Action Transmittal: 2026-25

Scope Change Request – City of Richfield 73rd Street Pedestrian Facilities

Subject: Scope Change Request for City of Richfield 73rd Street Sidewalk Project

Richfield - 73rd Street Sidewalk Location Map

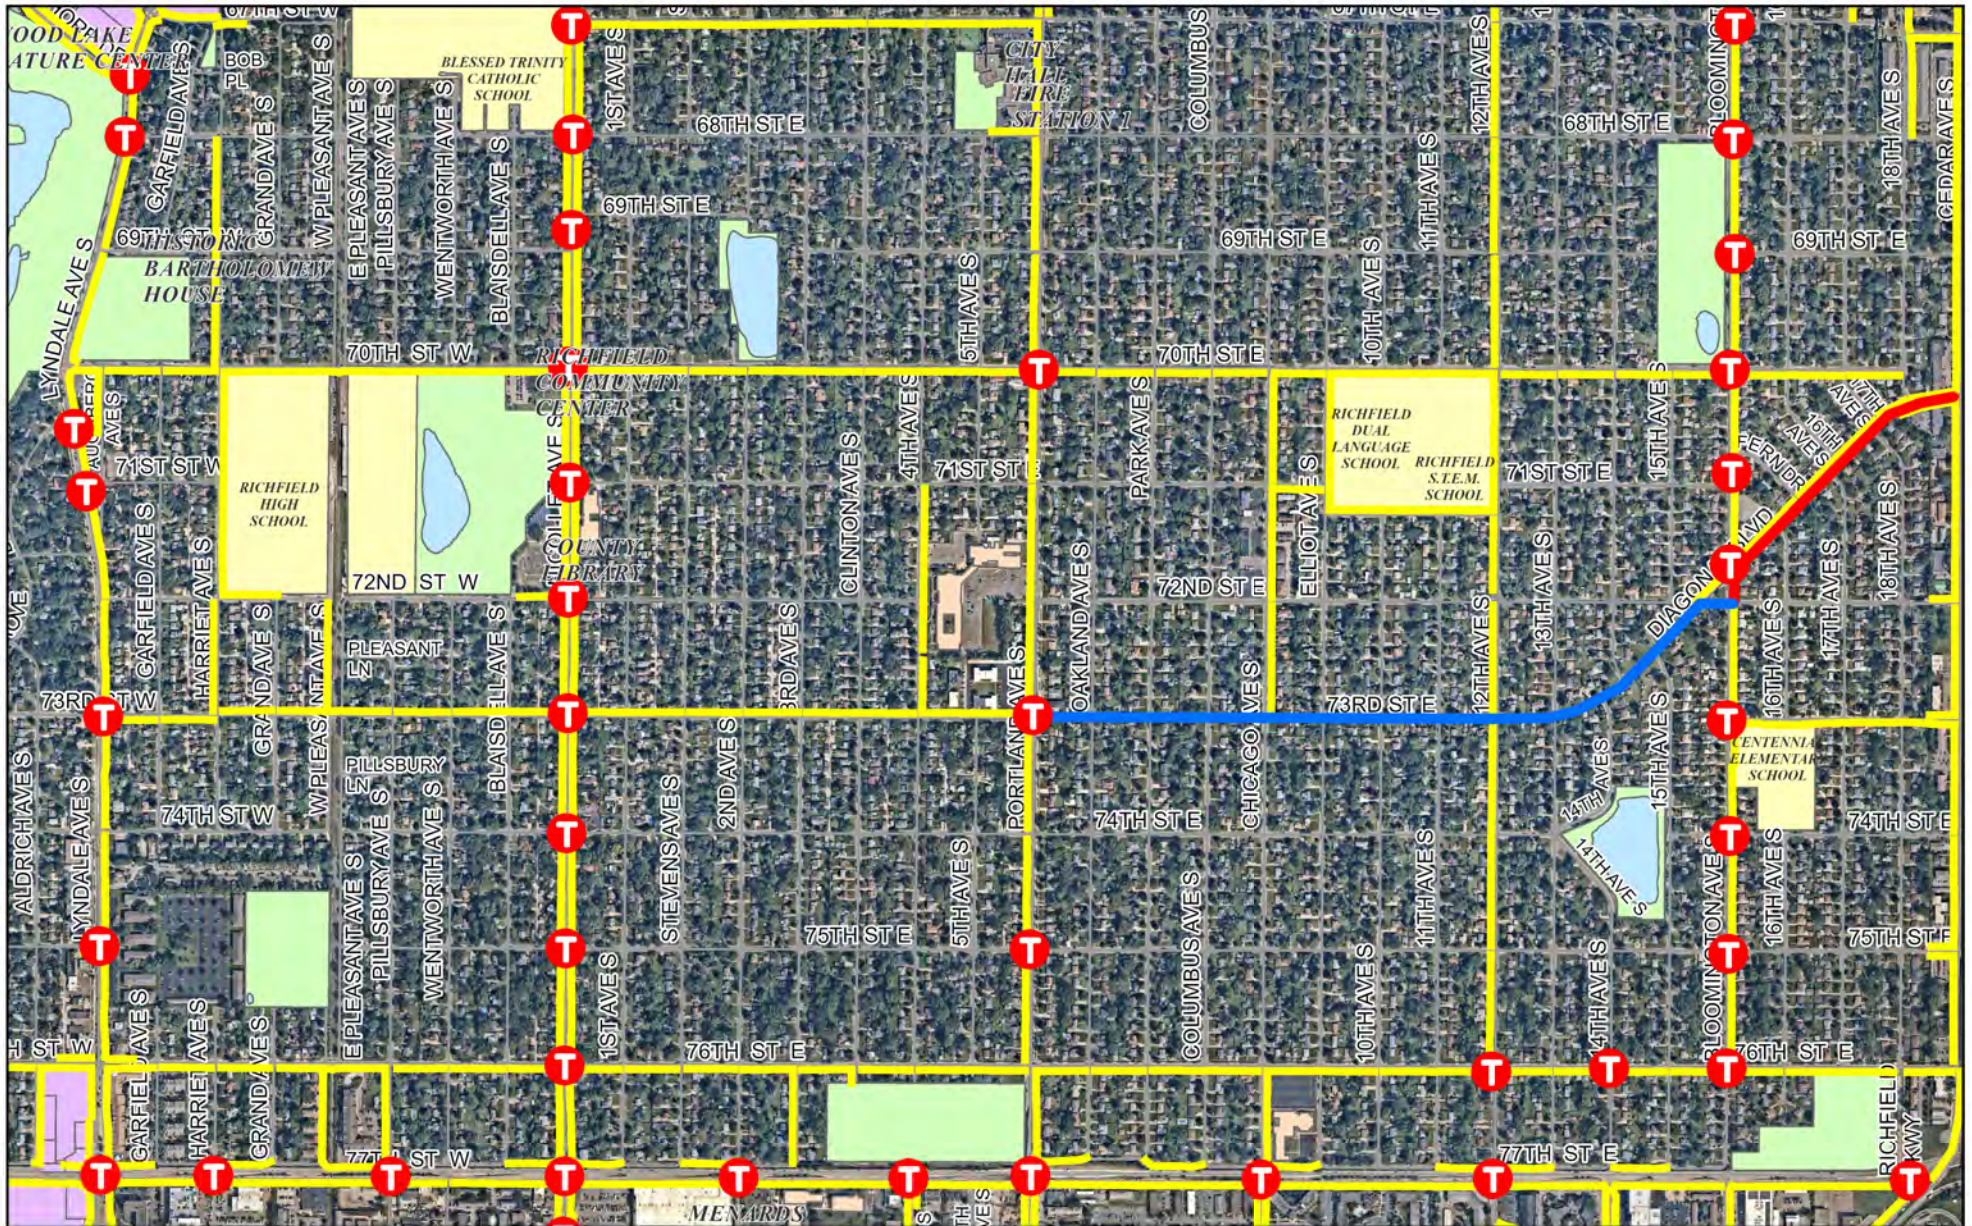
- Remove new sidewalk construction between Bloomington Avenue and Cedar Avenue from the project scope.
- Add bituminous path reclamation between Bloomington Avenue and Cedar avenue to the project scope.
- Update the total STIP cost estimate from \$1,307,550 to \$1,200,000 to reflect the updated project scope.
- Reduce grant funding by \$144,840 (from \$1,046,040 to \$901,200) to account for the change in scope
